# Access Compliance Report

## Public Rights-of-Way

Intersection ID: 17870	Main Street: HILLSDALE_AV	Cross Street: TRANQUIL_AV	Location: SW
ADA ID: B8172A3D7CFD	Ramp Type: Perp	Initial Pass/Fail: Fail	Overall Compliance: No
		Severity Score: 22.5

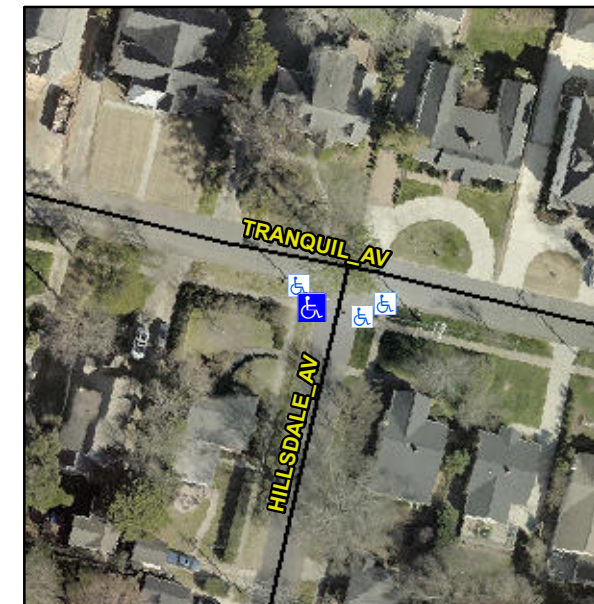
**R304.5.1, R304.2.2, R304.5.3**

Compliance	Description	Data	Compliance	Description	Data
N/A	Ramp Length (in)	96.0	No	Ramp Slope (%)	10.4
No	Ramp Width (in)	46.0	No	Ramp XSlope (%)	4.4
N/A	Flare Type LT	N/A	N/A	Flare Type RT	N/A
N/A	Flare Slope LT (%)	N/A	N/A	Flare Slope RT (%)	N/A
N/A	Flare Traversable LT?	N/A	N/A	Flare Traversable RT?	N/A
N/A	Landing Length (in)	N/A	N/A	DWS Provided?	N/A
N/A	Landing Width (in)	N/A	N/A	DWS Contrast?	N/A
N/A	Landing Slope (%)	N/A	N/A	DWS Length (in)	N/A
N/A	Landing X Slope (%)	N/A	N/A	DWS Full Width?	N/A
N/A	Landing Curb? (Y/N)	N/A	N/A	DWS Offset (in)	N/A
N/A	Shared Landing?	N/A			
N/A	Gutter Ponding?	N/A	N/A	Gutter Slope (%)	N/A
N/A	Gutter Lip Ht (in)	N/A	N/A	Gutter X Slope (%)	N/A
N/A	Painted X Walk1?	No	N/A	Painted X Walk2?	N/A
	X Walk 1 Direction	To SE		X Walk 2 Direction	N/A
N/A	X Walk 1 Width (in)	N/A	N/A	X Walk 2 Width (in)	N/A
	X Walk 1 Slope (%)	5.4		X Walk 2 Slope (%)	N/A
	X Walk 1 X Slope (%)	2.9		X Walk 2 X Slope (%)	N/A

**Remove & Replace Entire Ramp.**
